# Wisconsin Department of Transportation

**Proposal #47: 1610-03-62, WISC 2016191**  
**Medford - Westboro**  
**STH 102 to North County Line**  
**STH 13**  
**Taylor County**

This is Addendum No. 02, which provides for the following:

**ADDENDUM NO. 02**

Addendum No. 02  
ID 1610-03-62  
Revised Sheet 3  
April 28, 2016

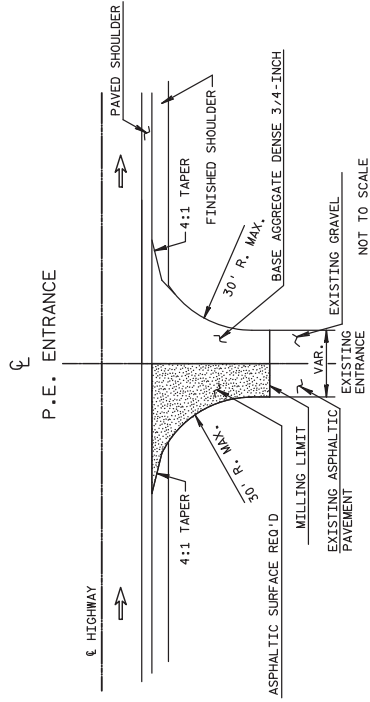
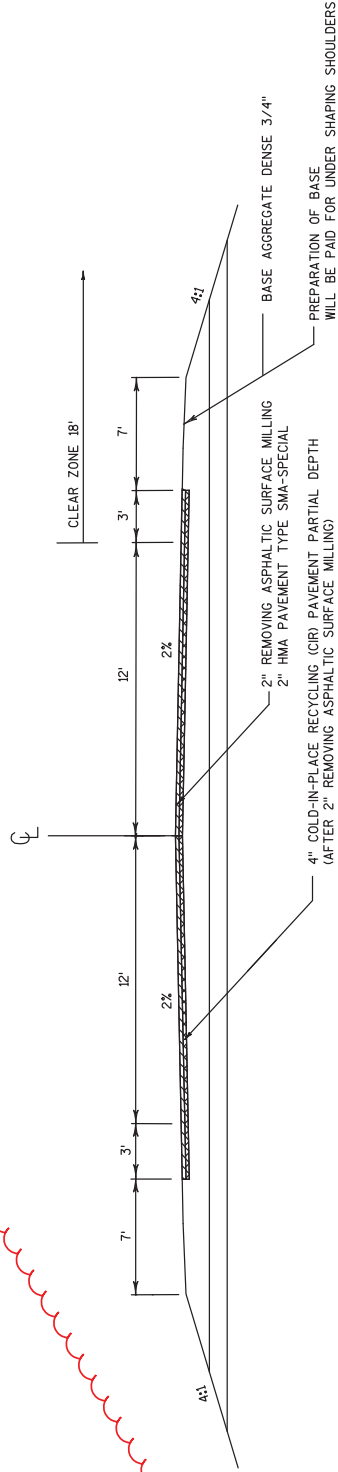
Revised Plan Sheets	
Plan Sheet	Plan Sheet Title (brief description of changes to sheet)
3	Typical Sections. Pavement Type Changed.
4	Construction Detail. Pavement Type Changed
36	Miscellaneous Quantities. Removed HMA Pavement 4 SMA 58-34 V Special Item. Added HMA Pavement Type SMA-Special item.
